PRODUCT ADVISORY

Data Sheet Specification Update for Intersil Product ISL54103*

**Refer to:
PA11111**

Date: October 14, 2011

Old POD MO-193 – PA11111

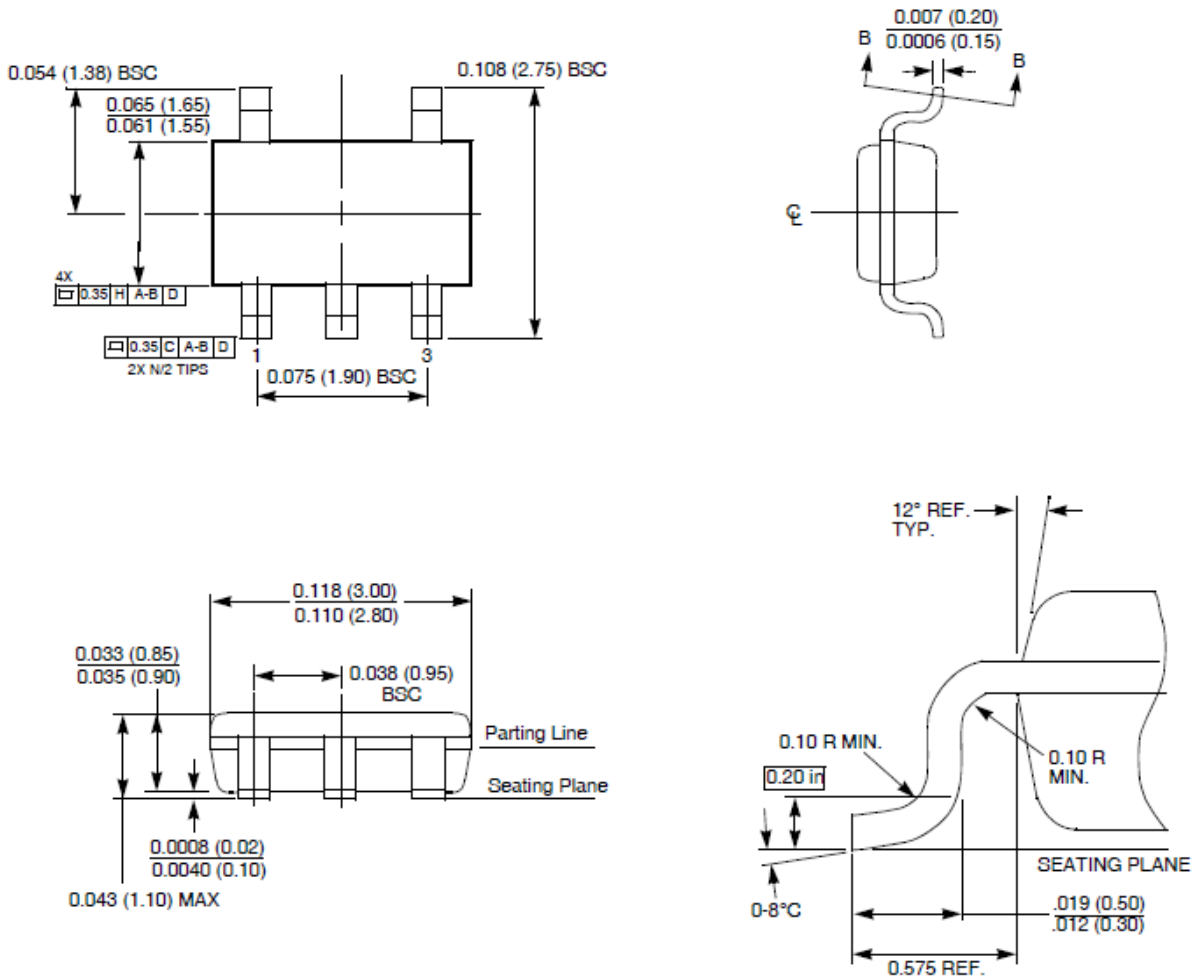
This advisory is to inform you that Intersil has updated the POD (Package Outline Drawing) referenced in the data sheet specification for the listed Intersil ISL54103* products. The POD has been changed to reflect JEDEC outline MO-178AA instead of JEDEC outline MO-193. The old and new PODs are contained on following pages. There have been no changes to the package or product itself. The updated data sheet is available on the Intersil web site at <http://www.intersil.com/data/fn/fn6303.pdf>.
